MANATEE COUNTY

June 17, 2009

SUBJECT: Invitation for Bid #09-1583-OV
17th Street West (From Business 41 U.S. 41 to U.S. 41)
Road and Utility Improvements, Palmetto, FL

ADDENDUM #3

CAD / ENGINEER	SHEET TITLE	PROJECT NO.	DATE
R.D.B. / N.T.K.	POND BORING LOCATION PLAN	DES 034798	11/19/03
PREPARED BY	PROJECT NAME	SCALE	SHEET NO.
 DRIGGERS ENGINEERING SERVICES, INCORPORATED	17th STREET WEST FROM BUSINESS U.S. 41 TO U.S. 41 MANATEE COUNTY, FLORIDA	1" = 200'	PLATE 1

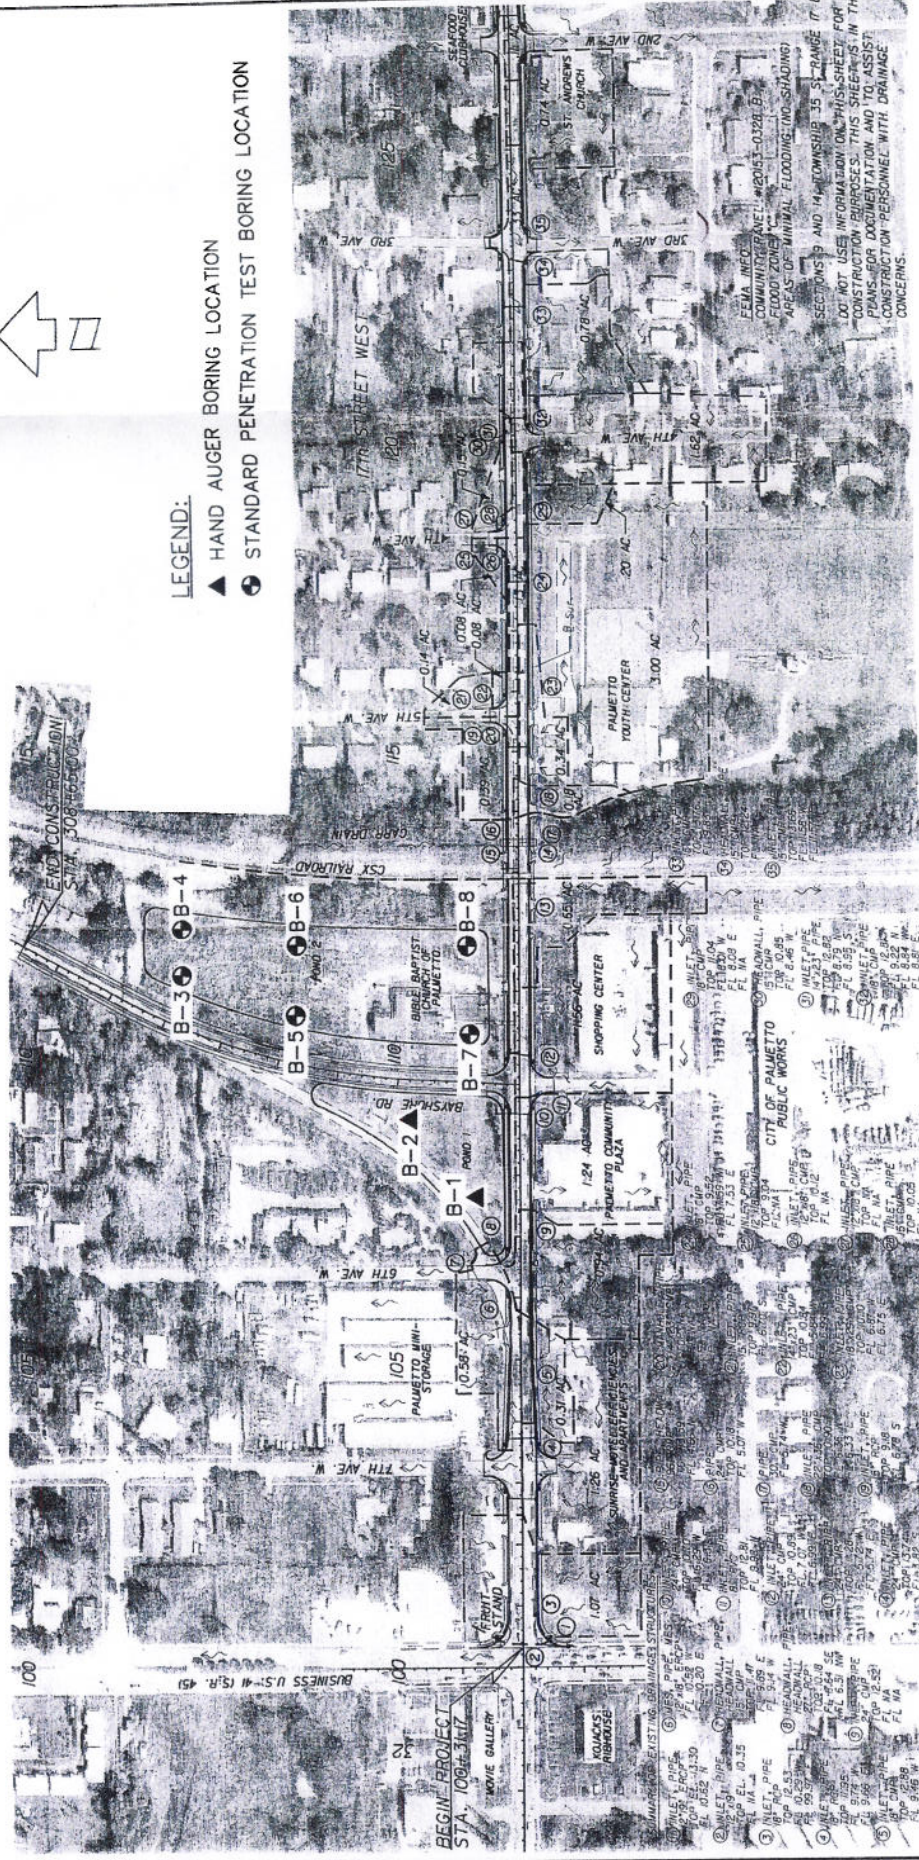
Attached (5) pages are excerpts of the current Geotechnical Report. The closest geotechnical data points to the proposed ConSpan are B-8 and HA-15 and HA-16. Please use this preliminary Geotechnical Data to assist you in determining the appropriate ConSpan footing for your Bid. More localized geotechnical data may be appropriate for the final design and the contractor would be responsible for obtaining this data.
